NOTICE OF MEETING
HILLSIDE REVIEW BOARD
CITY OF ST. GEORGE
WASHINGTON COUNTY, UTAH

HILLSIDE REVIEW BOARD AGENDA REPORT: 12/14/2022

1682 E. Howard Lane Hillside Development Permit (Case No. 2022-HS-019)		
Request:	A Hillside Development Permit to determine the ridgeline on lot 29 of South Rim at Formaster Ridge for the construction of an infinity pool.	
Applicant:	Ryan Andrews and Tonya Shepard	
Representative:	Lorin Orvin	
Location:	1682 E. Howard Lane	
General Plan:	Low Density Residential (LDR), Open Space (OS)	
Existing Zoning:	R-1-10 (Single Family Residential, minimum lot size 10,000 sf)	
Surrounding Zoning:	North	R-1-10
	South	R-1-10
	East	R-1-10
	West	R-1-10
Land Area:	Approximately 0.39 acres

Exhibit A

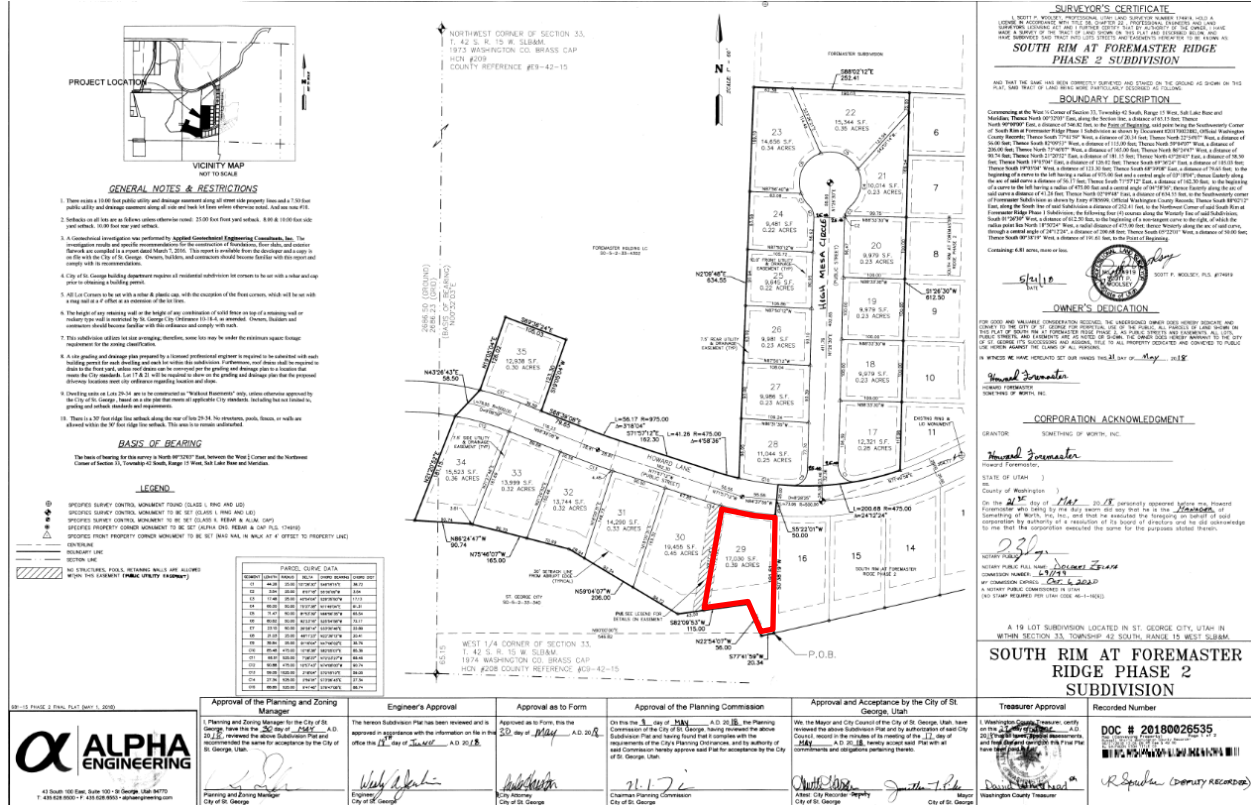
This is a request from the property owners of 1682 E. Howard Lane for the Hillside Review Board to determine the location of the ridgeline in the rear of their property. The owner is coming before the Hillside Review Board for the purpose of determining where they can place their infinity pool. Construction on the pool has already commenced but has not yet been completed.

This property is lot 29 of the South Rim at Formaster Ridge final plat. Note #10 on the final plat states:

10. There is a 30' foot ridge line setback along the rear of lots 29-34. No structures, pools, fences, or walls are allowed within the 30' foot ridge line setback. This area is to remain undisturbed.

The Hillside Committee determine the location of the ridgeline located in the rear of the property and whether the pool location meets the ridgeline setback requirement on the plat.
